WAIMAKARIRI DISTRICT COUNCIL
Resource Management Act 1991

HEARING REPORT

Hearing Date:	Commencing Wednesday 28 October 2015	Time:	9:30 A.M.
Hearing Venue:	Waimakariri District Council, Council Chambers, 215 High Street, Rangiora		
Subject:	Plan Change 40: Review of Parking, Loading and Manoeuvring

Figure 30.3: Minimum Sight Lines for Pedestrian Safety

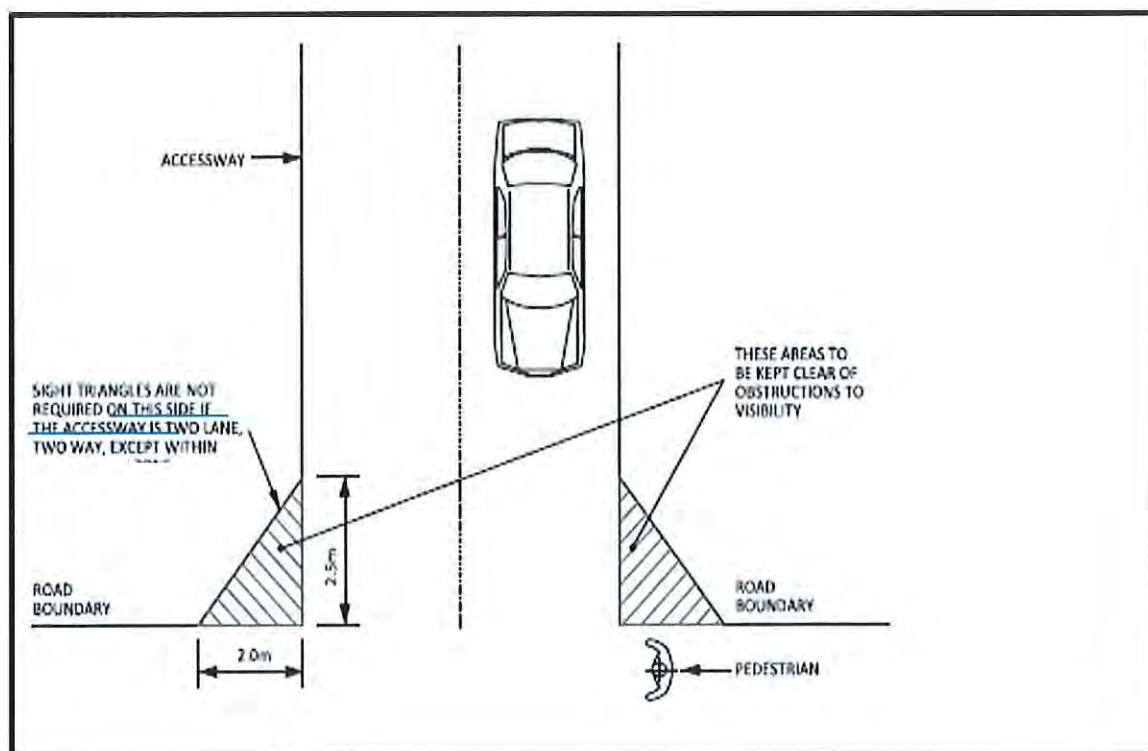
5.6.1 Submission 85.15 (Foodstuffs South Island) relates to Figure 30.3 and requests that additional wording to the NZ Standard in relation to Business Zones be removed. The wording has been amended slightly to reflect the terminology used in the District Plan, particularly 'accessway' instead of 'driveway' and 'road boundary' instead of 'property boundary'. I agree that the setbacks in the standard should be applied, and therefore recommend removal of the words '...except within any Business Zone' and adding the word 'adapted' to the figure reference, as shown below:

Figure 30.7: Parking Space and Manoeuvring Dimensions

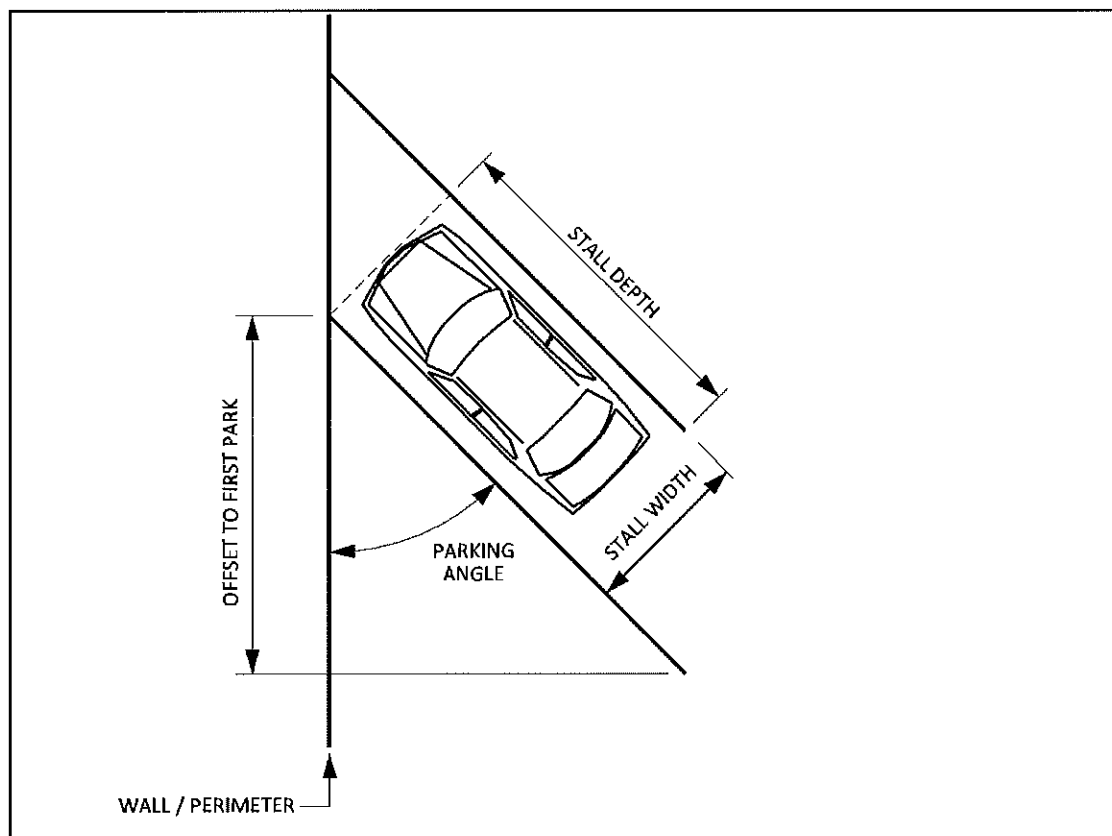
5.6.3 Submission point 85.18 (Foodstuffs South Island) identifies incorrect indications in Figure 30.7 in relation to stall depth. I agree that the stall indications have been incorrectly shown in relation to the figure supplied in the Abley 2013 Report and recommend revising Figure 30.7 as follows:
